PRE-APPLICATION SUMMARY LETTER

Subject: Poulsbo Place Division 8 Master Plan Pre-Application Summary Letter | P-07-02-18-01 |
Parcel No. 142601-13-138-2008 and 142601-13-139-2007

To: Charlie Wenzlau
From: Marla Powers, Associate Planner
Subject: Poulsbo Place Division 8 Redevelopment Master Plan; Pre-Application Conference;
Planning File #P-07-02-18-01
Date: July 31, 2018

to: Marla Powers, Associate Planner
from: Michael Bateman, PE, Development Review Engineer
subject: Poulsbo Place 2, Division 8 – Pre-application Comments
date: July 31, 2018

**Table 18.52A
Parking Stall Dimensions**

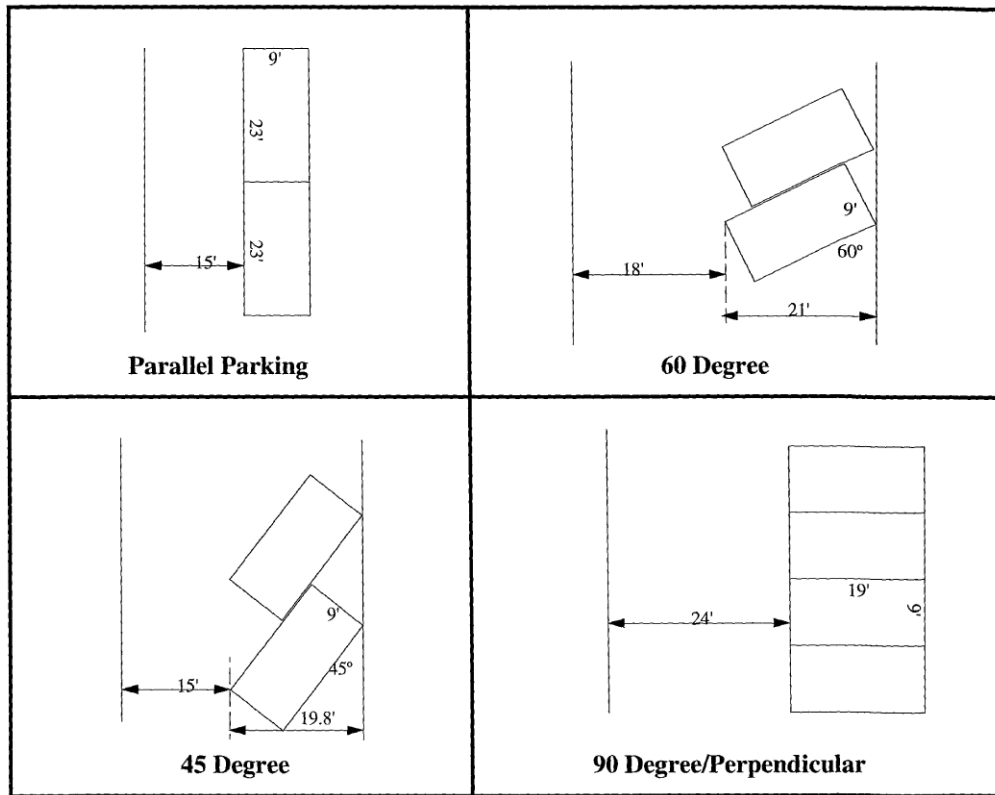
TOTAL PARKING = 145 spaces required. The proposal provides 120 parking spaces.

The Redevelopment Master Plan, page 39, states that on-street parking may be used to meet minimum parking space requirements. Further, the Redevelopment Master Plan, also on page 39 and in the MDNS states that off-street parking may be reduced when the City finds that provisions have been made in the Covenants, conditions and restrictions (CC&R's) to provide reciprocal use agreements. The extent of the reduction (20% maximum) shall be determined by the Planning Director based on information not yet submitted showing location of parking spaces and proposed land uses and how these spaces and uses relate to property lines and multiple use structures.

The 1994 ZO does not contemplate compact parking spaces, dimensional standards are based on Table 18.52A as follows:

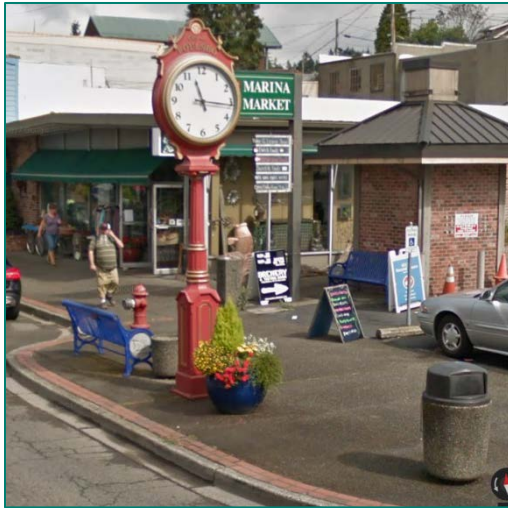
Front yard and street setback will need to be increased or modified through a requested amendment.
